LEE VELLA SUBDIVISION

APPLICATION NUMBER 22 DATE October 18, 2007

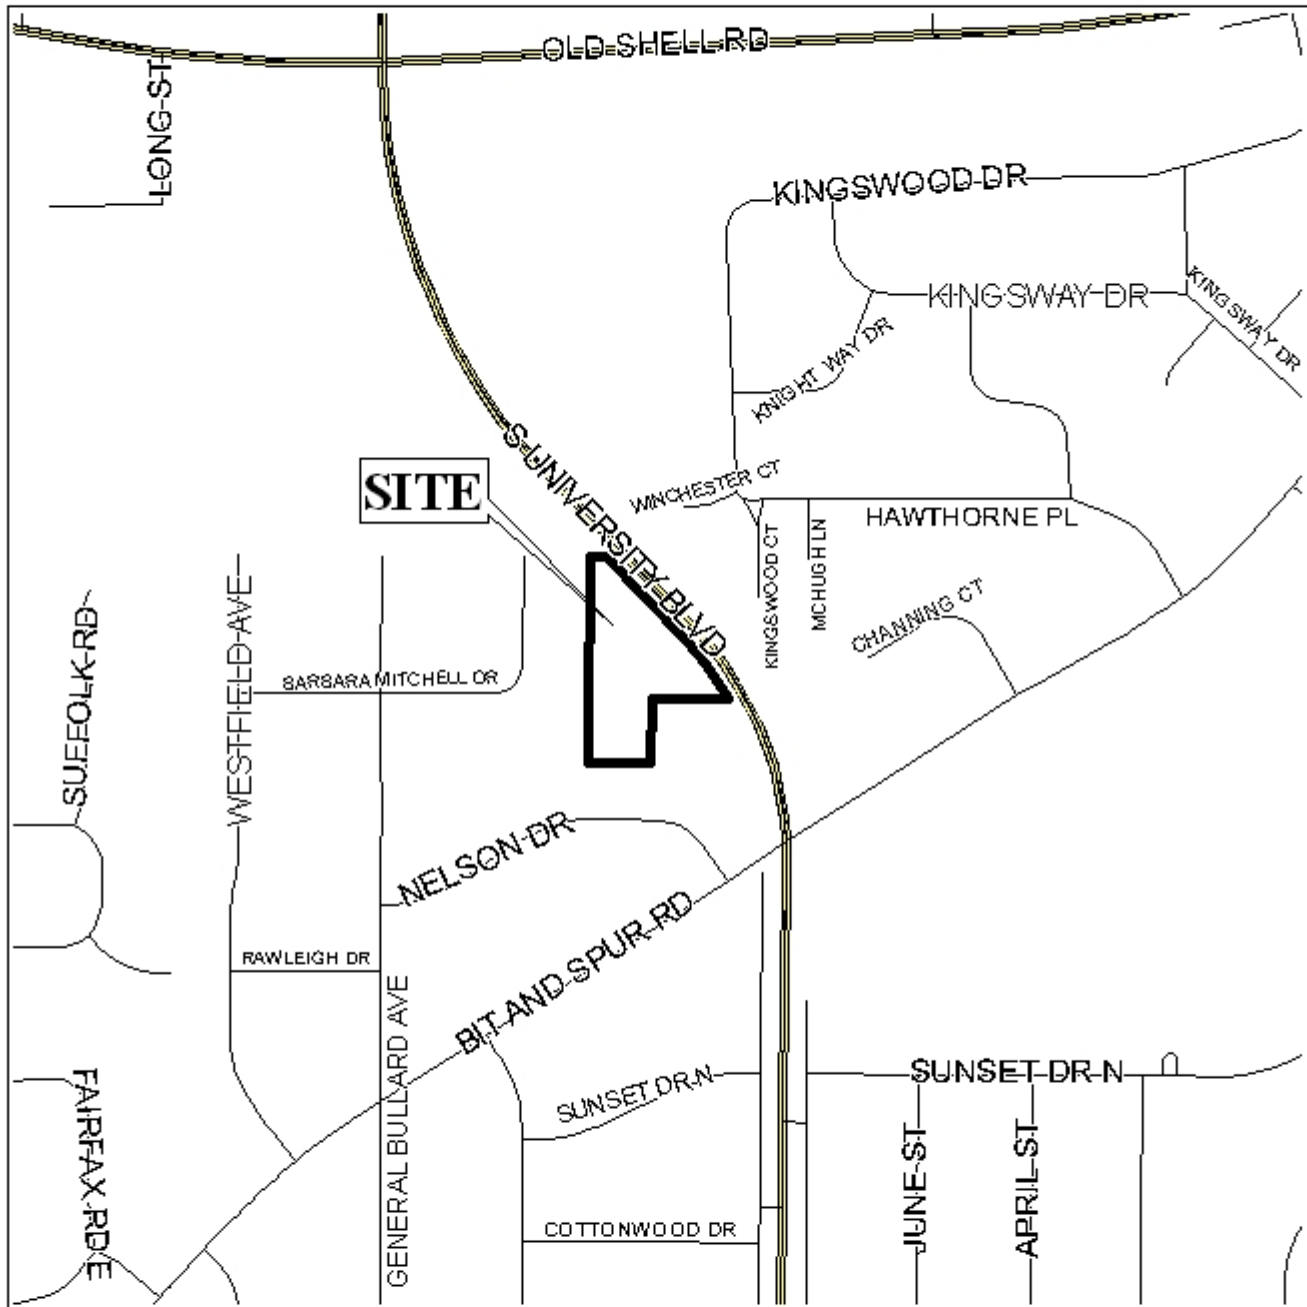
The site has approximately 596 linear feet of frontage along South University Boulevard. However, University Boulevard is a major street, and given its traffic density, access management is a concern; therefore, a note should be placed on the final plat stating that the site is limited to two curb cuts, with the size, location and design to be approved by Traffic Engineering and conform to AASHTO standards.

The proposed lot is not labeled with lot number and square footage, and there is no mention of storm water detention on the plat, which should be addressed prior to signing the final plat. The site is zoned B-3 and requires no side or rear yards. However, a ten foot buffer strip shall be

provided where the site abuts residential properties, in compliance with Section 64-4 of the Zoning Ordinance.

- 1) labeling of the lot with its size in square feet, or the provision of a table on the final plat with the same information;
- 2) placement of a note on the final plat stating that the site is limited to three curb cuts, with the size, location, and design to be approved by Traffic Engineering, and conform to AASHTO standards;

- 3) provision of a 10 foot buffer strip along the west and south boundary lines of the proposed lot; and
- 4) subject to the Engineering Comments (*It is the responsibility of the applicant to look up the site in the City of Mobile (COM) GIS system and verify if NWI wetlands are depicted on the site. If the COM GIS shows wetlands on the site, it is the responsibility of the applicant to confirm or deny the existence of wetlands on site. If wetlands are present, they should be depicted on plans and/or plat, and no work/disturbance can be performed without a permit from the Corps of Engineers. Must comply with all storm water and flood control ordinances. Any work performed in the right of way will require a right of way permit.*)
